Delegated Report		Analysis sheet		Expiry Date:		12/04/2021	
		N/A / attached		Consultation Expiry Date:		14/03/2021	
Officer				Application Number(s)			
Angela Ryan				2021/0194/P			
Application Address				Drawing Numbers			
9 Fitzroy Road London NW1 8TU				See decision notice			
PO 3/4	Area Team Signature	C&UD	Authorised Officer Signature				
Proposal(s)							
Erection of a mansard roof extension to dwelling house							
Recommendation(s):		Refuse planning permission					
Application Type:		Householder Application					
Conditions or Reasons for Refusal:		Refer to Draft Decision Notice					
Informatives:							
Consultations							
Adjoining Occupiers:		No. notified	00	No. of responses	00	No. of objections	00
				No. electronic	00		
Summary of consultation responses:		A site notice was displayed between 17/02/2021 to 13/03/2021, and an advert displayed in the local press between 18/02/2021 to 14/03/2021. No objections/representations have been received as a result of the consultation process

1.1 This application seeks planning permission for a mansard roof extension to accommodate an additional bedroom for the existing terraced house. 2 dormer windows are proposed to be installed

Fig 1. Street view Fitzroy Road

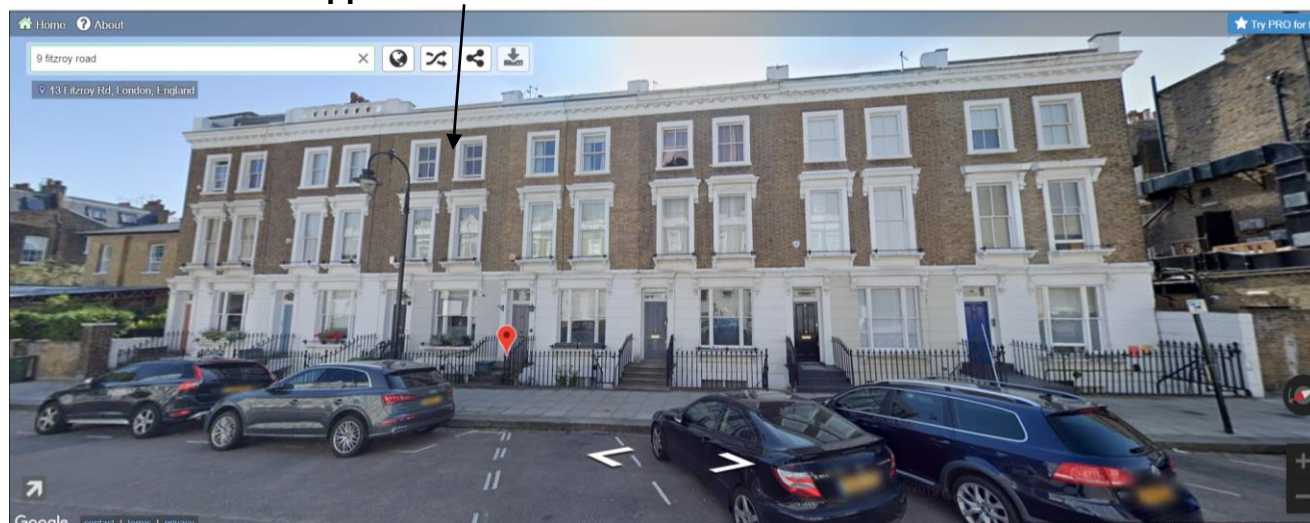
2.9 The proposal is therefore considered to be unacceptable in principle and would be contrary to policy D1 of Camden's Local Plan 2017. Furthermore the existence of a roof extension at no. 5 at the end of the terrace is not considered to set a precedent for further extensions here due to its age, having been approved several decades ago in 1985 under a different planning policy context.

Fig 2. Aerial view showing unaltered valley roofs of group of buildings located at 7-17 Fitzroy Road

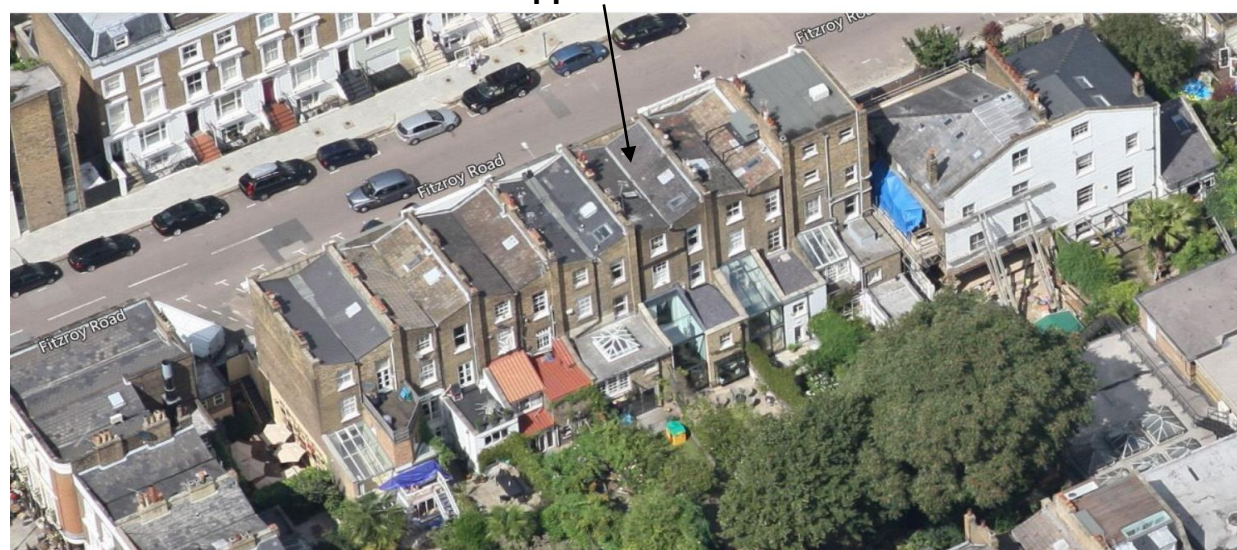
2.10 The properties located on the east side of Fitzroy Road show a strong eaves line, with a strong presence, where there is a repetition of an unaltered roofline, which the Council considers is one of the characteristics that makes up the streetscape character. It is considered that the proposal to add a mansard roof extension at the application site would be harmful in terms of its design as it would result in the loss of an original valley roof where the majority of the valley roofs remain intact. It is also considered that the development would be harmful to the existing streetscape by marring the existing repetition of identical units, not only by adding the mansard but by raising the parapet walls on either side and heightening the existing chimney, which would set incongruous features within the existing townscape, setting an unacceptable precedent. As the proposed mansard roof extension is fairly large

and of a conventional design, it is considered that it would be visible from long views along Fitzroy Road.
